Title - Sujet Roof Restoration	
Solicitation No. - N° de l'invitation EZ899-170597/A	Amendment No. - N° modif. 001
Client Reference No. - N° de référence du client	Date 2016-07-22
GETS Reference No. - N° de référence de SEAG PW-\$PWY-026-7822	
File No. - N° de dossier PWY-6-39065 (026)	CCC No./N° CCC - FMS No./N° VME
Solicitation Closes - L'invitation prend fin at - à 02:00 PM on - le 2016-08-03	
F.O.B. - F.A.B. Plant-Usine: <input type="checkbox"/> Destination: <input checked="" type="checkbox"/> Other-Autre: <input type="checkbox"/>	
Address Enquiries to: - Adresser toutes questions à: Yi (PWY), Patty	Buyer Id - Id de l'acheteur pwy026
Telephone No. - N° de téléphone (778) 919-2578 ()	FAX No. - N° de FAX (604) 775-6633
Destination - of Goods, Services, and Construction: Destination - des biens, services et construction: CBSA - Osoyoos Border Crossing - Osoyoos, BC

Osoyoos Roof Restoration
Osoyoos Border Crossing,
Osoyoos, BC
Solicitation No: EZ899-170597/A

Project Name: Osoyoos CBSA Border
Crossing – Roof Restoration

Addendum #1

LOWER ROOF PLAN

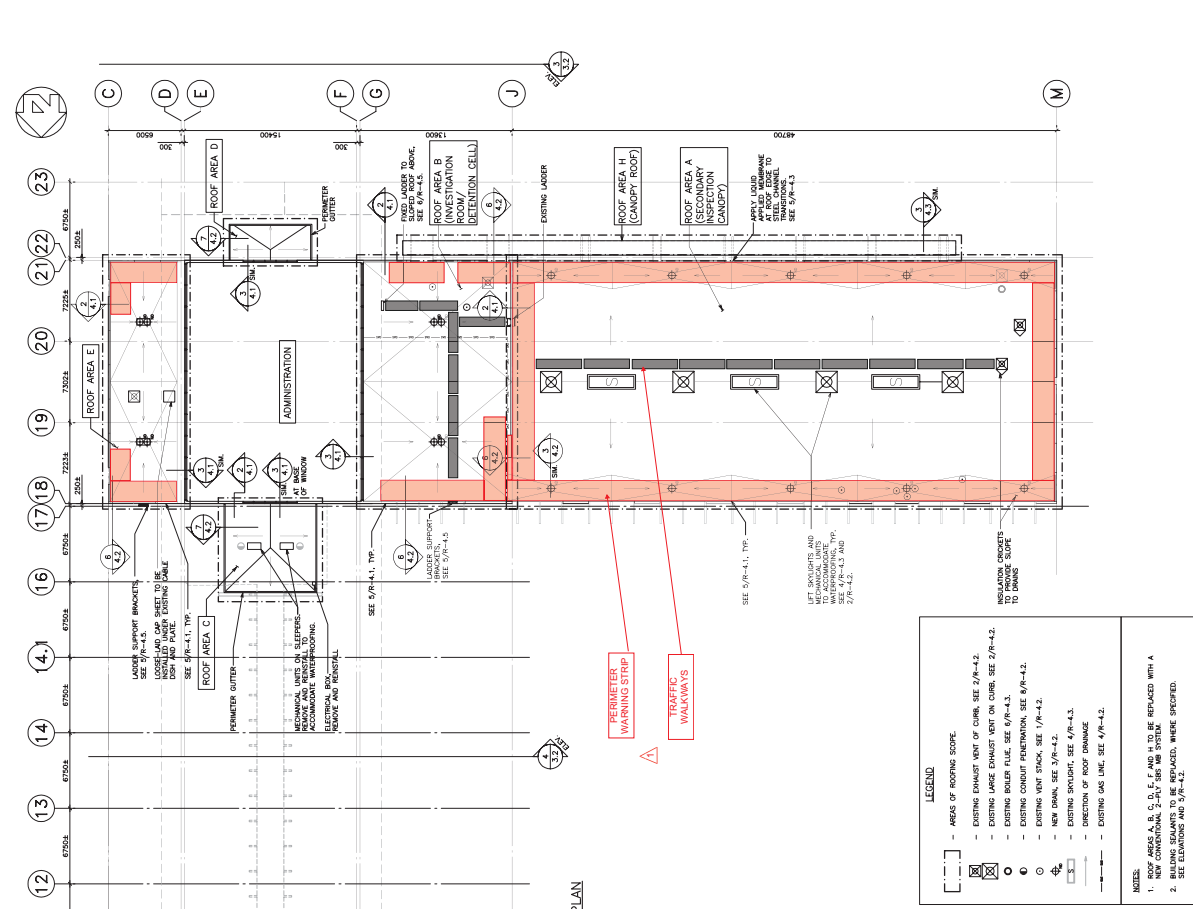
Question 8: Section 075200 Products 2.9.1 and .2 there is no indication on roof plan where these walkways and perimeter strips are to be installed. Also if a perimeter strip is used can the change of color be incorporated into the field membrane or does a second layer need to be installed on top of the field membrane.

Drawing R-2.1 - Lower
Roof Plan

Add approximate perimeter warning strip and traffic walkways layout.

Clarification 8: Refer to revised Detail R-2.1 showing the general layout of the traffic walkways and perimeter warning strip. The perimeter strip may be incorporated into the field membrane in the location of the membrane seams. The perimeter strip install orthogonal to the membrane seams shall be an additional layer.

UPPER ROOF PLAN

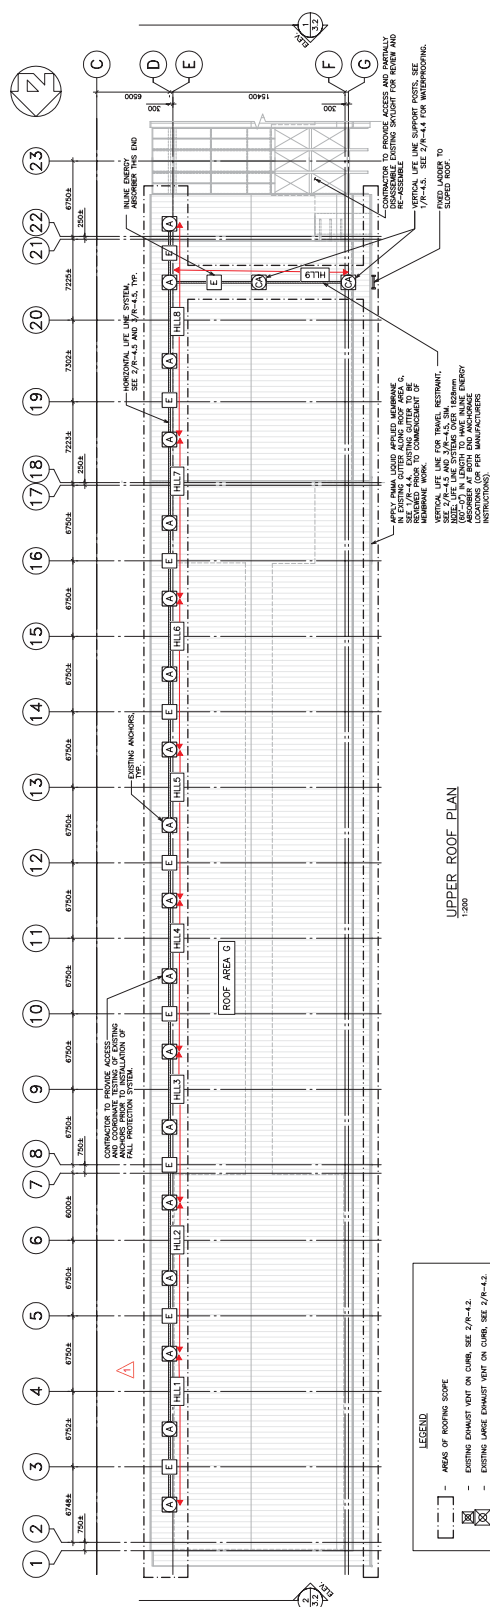
Question 2: It is not clear at which anchor any of the horizontal lifelines begin or end. It is noted that depending on their length they may require more than one energy absorber making it necessary to know where they are expected to begin and end. It would also be beneficial to know what the existing anchors are (what brand, d-ring configuration) this information should be available on the existing engineered drawings required for permanent anchors. What is the plan, or course of action for any anchors that fail testing?

Drawing R-2.2 – Upper
Roof Plan

Clarify beginning and end location of each Horizontal Life Line.

Clarification 2: Please refer to the clarifications outlined in Detail R-2.2, showing the beginning and end of the horizontal life lines (HLL). Generally, each life line includes 3 anchors and contains one energy absorber, except for HLL8 that has two energy absorbers due to the span. Existing anchor drawings and detailed information about the anchors is not available. If the existing anchor testing fails, additional scope of work will be discussed at that time.
